**IEEE Std 497-2002**  
(Revision of IEEE Std 497-1981)

# Errata to IEEE Standard Criteria for Accident Monitoring Instrumentation for Nuclear Power Generating Stations

*Correction Sheet*

**Issued 20 February 2003**

**Figure 1— Display channel**

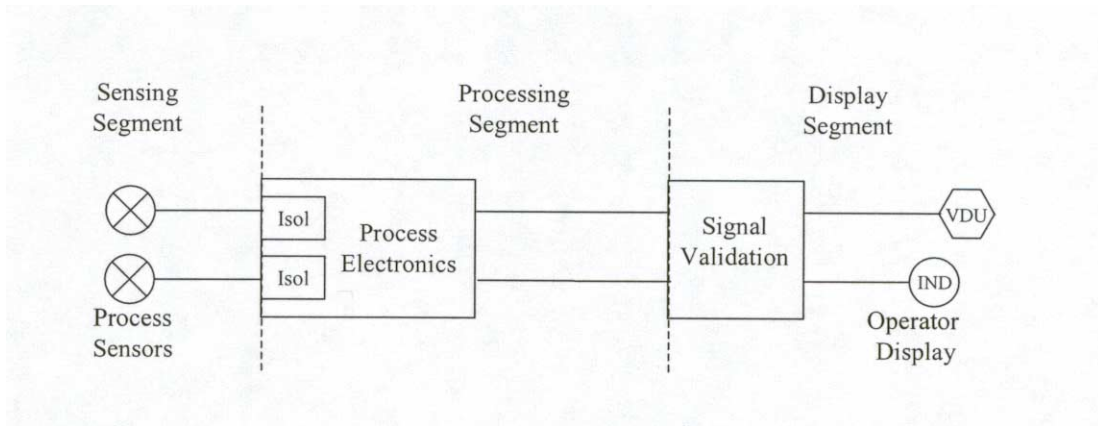
Page 5, Figure 1—Display channel, is incorrect. The figure should read as follows:

**Figure 2—Examples of monitoring channel displays**

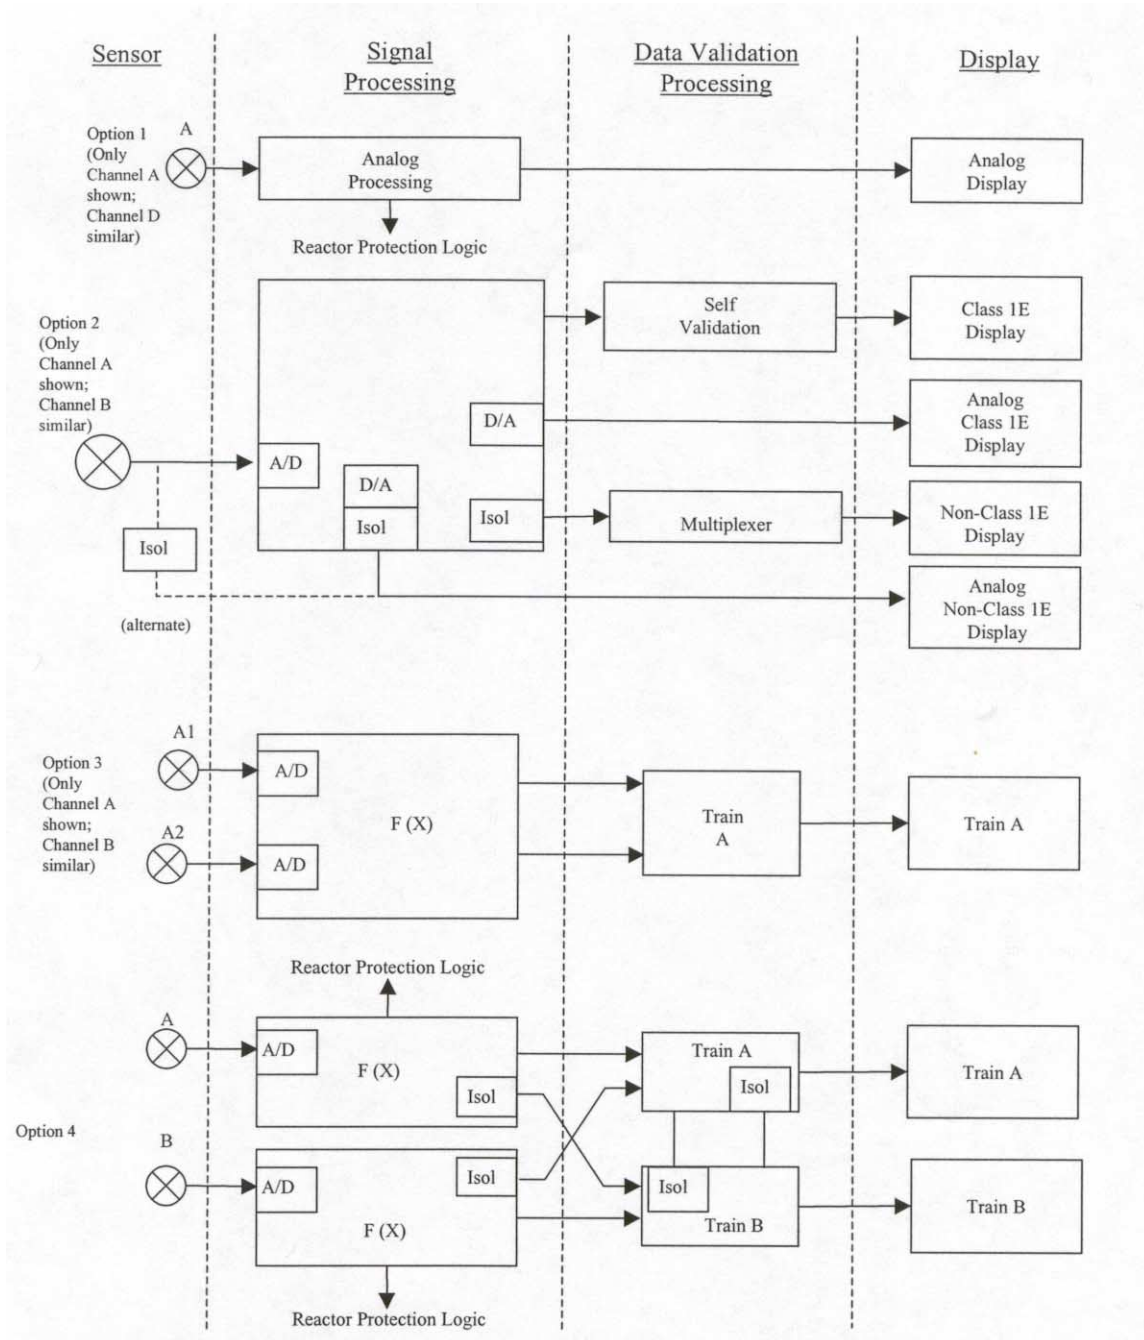
Pg 16, Figure 2— Examples of monitoring channel displays, is incorrect. The figure should read as follows.
